ADDENDUM NO. 3
June 6, 2023

2023 RECONSTRUCT TERMINAL BUILDING
AIP No. 3-27-0025-20-2023
SKY HARBOR AIRPORT
DULUTH, MN

This addendum consists of 2 pages and Drawing Nos. G2.10, C3.00, C4.00, C5.01, A301, S101, S502, and S504.

K SECTION THROUGH CONCRETE SLOPED WALK AND SLAB
S502 ORIGINAL SCALE: 1/2" = 1'-0"

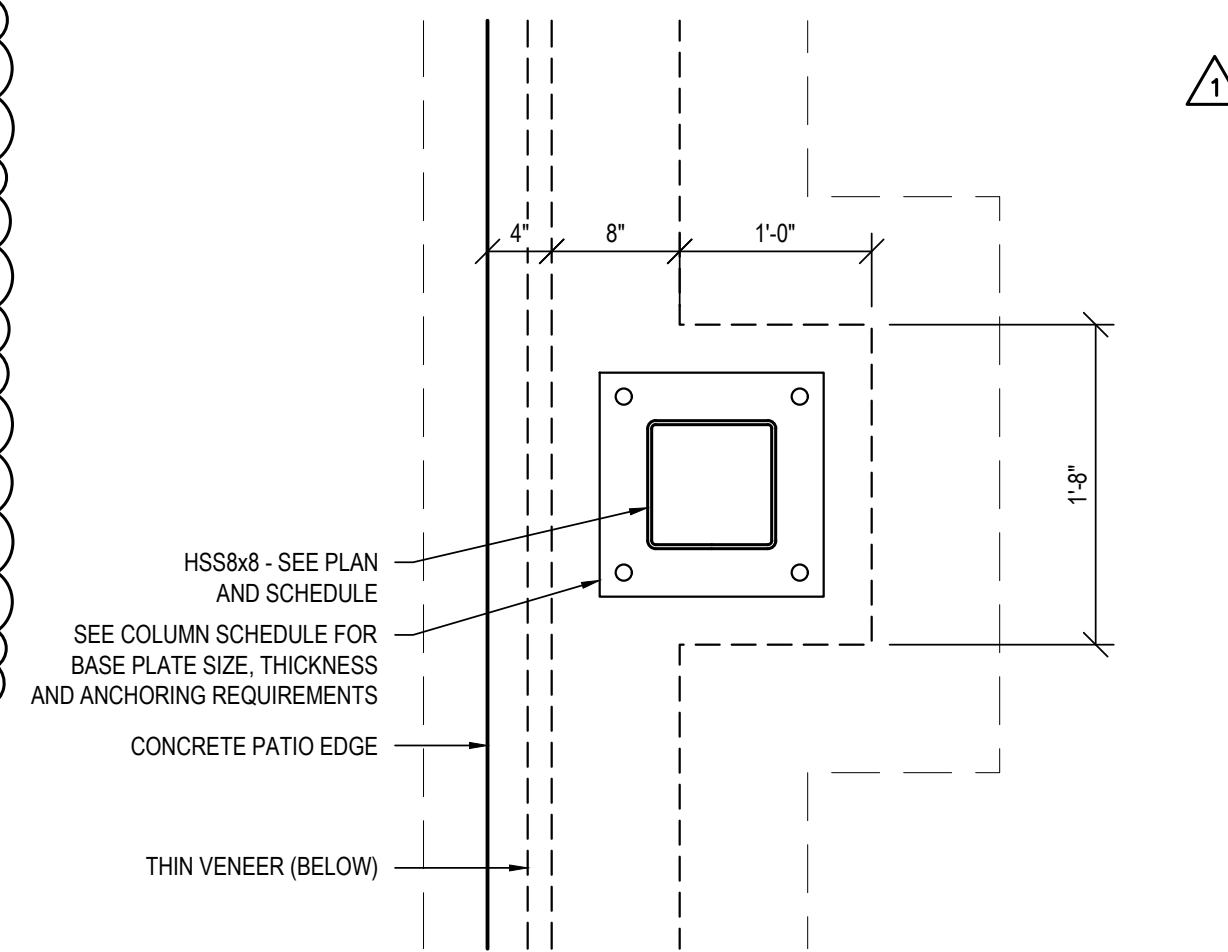
5. DELETE the following drawings and REPLACE in their entirety with the attached revised drawings:
 - A301, S101, S502, and S504.
 - i. Added detail related to thickened edge for sloped walk on northside of building.

E SECTION THROUGH CANOPY
S504 ORIGINAL SCALE: 1/2" = 1'-0"

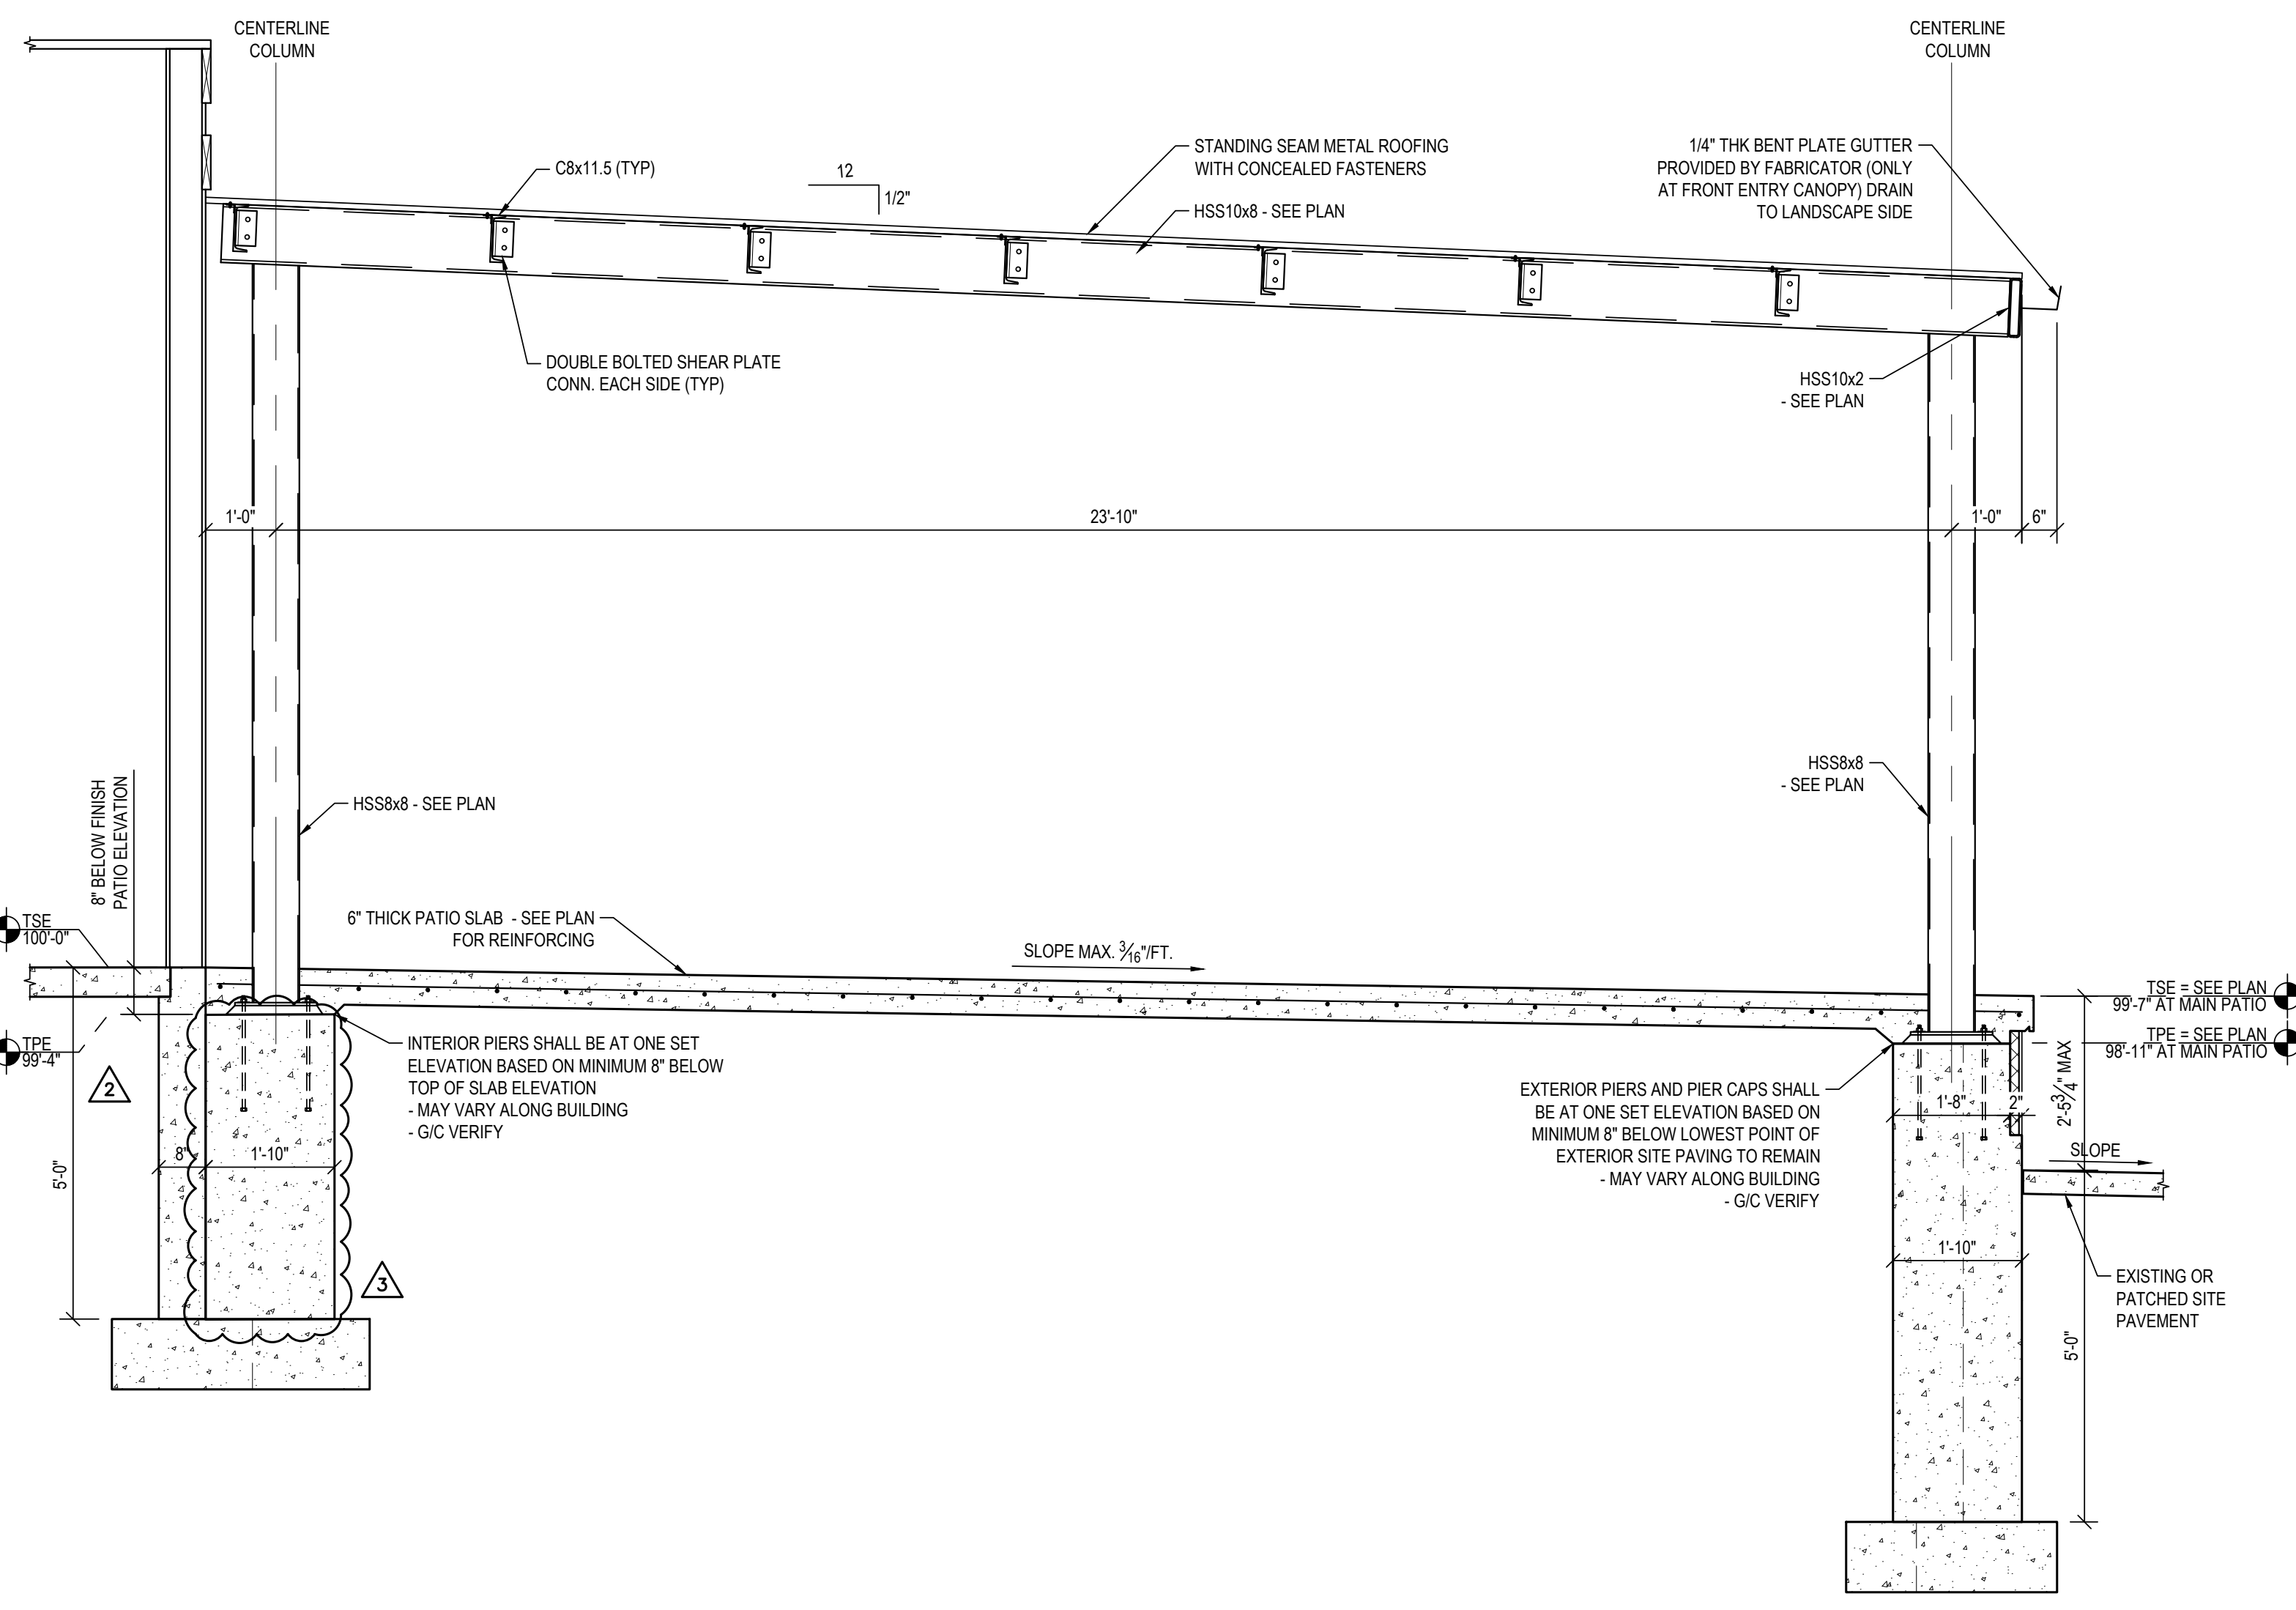
ADDED SHEET AND REVISED SECTION THROUGH CANOPY
